## SERVICE LETTER 59

### Removal of Main Gear Tunnel for 13000 Seaplane Floats

<b>Aircraft Makes/Model(s):</b>	<b>Float Model(s):</b>	<b>Compliance:</b> Optional	<b>By:</b> MAS
DeHavilland DHC-6	13000S	<b>Part Number:</b> 1002437	<b>Approved:</b> DRH
		<b>Date:</b> 9/7/2022	<b>Revision:</b> C

**Figure 1**

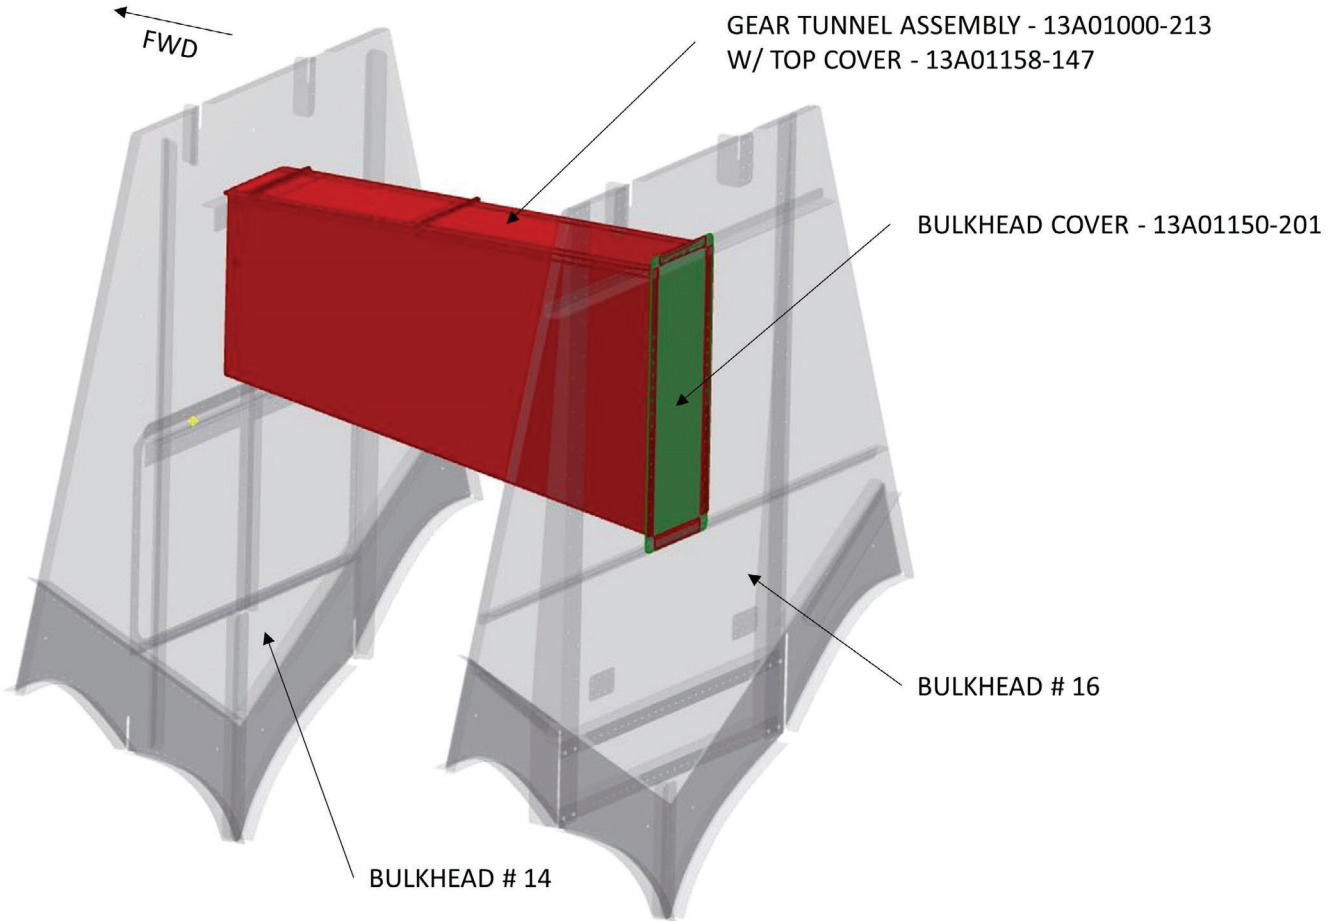
Model 13000 seaplane floats were manufactured with provisions for converting from amphibian floats. The gear tunnel between bulkheads #16 and #14 may be removed to make seaplane floats more accessible for repair and service. Since gear tunnel is removed, bulkhead #14 service cover may be enlarged for easier access.

1. From inside of float through access panel in #14 bulkhead, remove rivets (tails) that attach tunnel to #16 bulkhead.
2. On forward side of tunnel on #14 bulkhead, remove the two attach bolts and two attach rivets.
3. Remove tunnel.
4. On #16 bulkhead attach 13A01150-201, cover over opening. Holes in cover will match hole pattern in #16 bulkhead. Seal completely and cherry max rivet cover to bulkhead. Seal rivets after installation.
5. Plug holes in #14 bulkhead made from tunnel removal.

1. Remove existing access cover.
2. Remove center "T" angle above access hole.
3. Remove .75 x 1.00 stiffener angle from top of access door.
4. Mark out and remove 6" from top of door opening. Radii corners.
5. Position and install new door 13A01000-459 in lower holes. Use the new door to position upper .75 x 1.00 angle that was removed. Install same as it was removed.
6. Plug holes in bulkhead where center "T" section was removed.
7. Install new door and seal.
